# UNITED STATES PATENT AND TRADEMARK OFFICE

APPLICATION NO.	FILING DATE	FIRST NAMED INVENTOR	ATTORNEY DOCKET NO.	CONFIRMATION NO.
10/027,389	12/21/2001	Ronald E. Cole	1007-0542 / M7273.1	1177

**Office Action Summary**

### **DETAILED ACTION**

Figure 1

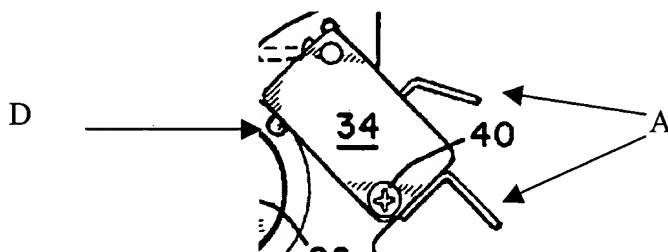
maintained on said support and selectively actuated by said cam plate, see col. 4, lines 10-14; a plurality of terminals (A) associated with said plurality of switches and maintained on said support (10). Swartzell does not positively disclose that the plurality of terminals are configured to connect to a single terminal interface, however, it is disclosed that said switches are connected to the over control. Barnett discloses a motorized over door latch control that teaches the use of a switch (200) having a plural sets of terminals configured to connect to a single quick-connect terminal interface.

In regards to claims 11 and 18, one of Swartzell's plurality of switches includes a door position switch (54; see col. 4, lines 15-16). In regards to claims 12 and 19, at least some of said plurality of switches (34 & 36) are actuated by cam (26; see col. 4, lines 10-15). As it concerns claims 13 and 20, Swartzell further comprises a flat cam plate (generally 32) in communication with and driven by said cam, said flat cam plate in communication with at least some of said plurality of switches (34 & 36; see col. 4, line 12). In regards to claims 14-17, the Swartzell and Barnett references disclose a door latch mechanism for a self-cleaning over comprising a support (10), a rotating cam (26), a motor (24), a cam plate (generally 32), a latch mechanism (14), a plurality of switches (34, 36, & 54), a plurality of terminals (A) associated with said plurality of switches, wherein said plurality of terminals are ganged to permit connection to a single point terminal connector as set forth above. In regards to claim 21, Swartzell discloses a latch
